# Floyd Hill CMGC Technical Team

### **Meeting Summary**

September 22, 2023, 9:00 to 12:00 PM

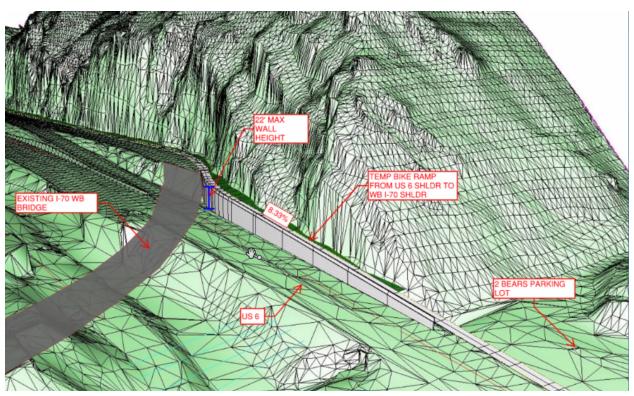
- The Matrix explored the three options that the TT had been discussed before:
  - Option A: Provide messaging that cyclists should use 103 as a detour
  - Option B: A combination of the 103 detour plus providing a shuttle service for cyclists
  - Option C: I-70 adjacent detour
- **Question** (Amy Saxton, Clear Creek County): Are all options feasible?
  - **Response**: There are concerns associated with Option C, including:
  - Reliability of keeping the trail open with rock fall. The detour is not viable for the full period that the trail is impacted; rock blasting will be happening near the maintenance facility and will close the trail.
  - Impacting emergency services due to constrained lanes and shoulders for a 1-2 mile stretch.
- The trail closure will last about 3 years.

- Mike Raber expressed concerns that it will likely be a longer closure, closer to 3-5 years, and noted that the detour could allow for some emergency access if needed.
  - Matt Aguirre: it's not a viable option for emergency services to use a 6ft wide shoulder. There would be a concrete barrier in the middle between the shoulder and bikeway which would block access for emergency services.

- By providing a shuttle (Option B), there would not be a full closure of the trail.
- Mike Raber: this is a critical throughput for cyclists. With a shuttle, you get into issues with capacity and bike racks.

- Bill Coffin, Saddleback Community POA: I would like to hear the shuttle plan. On a shuttle you would likely need a trailer because many people will not want to put their carbon fiber bikes on the bike rack and may be traveling with a bike trailer as well.

- Comment (Mandy Whorton, Peak Consulting): The liability of CDOT, FHWA, and Atkins needs to be considered under safety. If something happens, there is a lot of liability involved.Safety issues are significantly greater for Option C. Maintenance will be a safety/liability concern as well.

- **Response:** The Team is looking into the details of shuttle service and will have more information to share at subsequent meetings.
- The draft Matrix was shared to receive TT input.

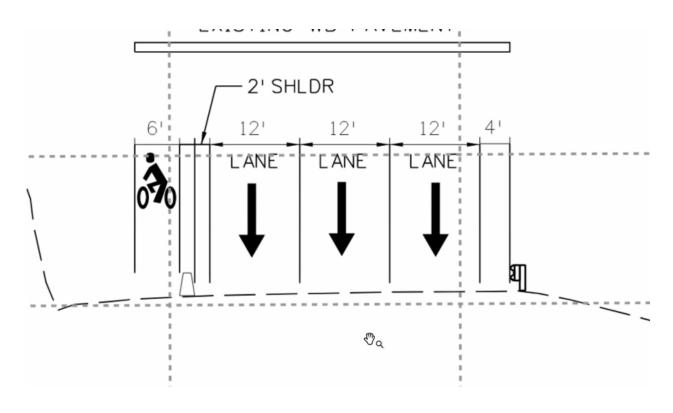
- **Comment** (Mike Raber): I would be happy to work with the team on the shuttle option. Clear Creek county has 4 of the most iconic climbs and we don't want to decrease bicycle tourism income.

- Amy Saxton: We could have a marketing campaign about the 103 detour.
- **Comment** (Bill Coffin): There will need to be some ability and requirement to update/adapt the shuttle service. We really appreciate the conversation and the options versus a full closure.

- ACTION: Add impact to cyclists as a row at the bottom of the Matrix.
- For the "community preferences" criteria, Amy Saxton expressed that there is not agreement or aligned community preference on Option C.

- Mike Raber suggested an update to CDOT signage that says 3 ft to pass versus just a sign with a bike on it, and to include messaging that if a cyclist is going the same speed as a car, they can use the full lane.

- **ACTION**: Atkins to follow up on item 18.
- Item 19: Emergency pull offs are a design criteria.
- Amy Saxton: another data point to consider is how long Option C would be in place and how the bike lane would affect drivers.

- Comment (FHWA): we support these conversations. For the 103 detour, would anything additional be needed?
  - Response (Tyler Brady, CDOT): If this option moves forward, there will be signs at either end including a map and a description of the detour.

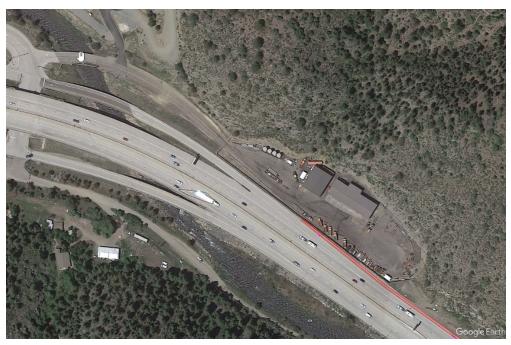
- **Question** (Tracy Sakaguchi, CMCA): Is the bike path at grade with the road? It becomes stressful in a big truck to not be able to see.
  - **Response:** Yes, it is at grade.
- The graphic shows a third merging lane, but the majority of sections there are only 2 lanes. This means that in an emergency response, this section would be down to 1 lane.
- **Question** (Paul Aguilar, FHWA): Is a 6ft wide bike path enough space for bi-directional bike traffic?
  - **Response:** 8ft is supposed to be the minimum but the other 2ft are needed for a concrete barrier.
- In some locations the shoulder is 8ft, but in others, construction would need to take place to widen the shoulder in order to fit the bike path.
- The west end of the detour concludes at a CDOT maintenance yard.
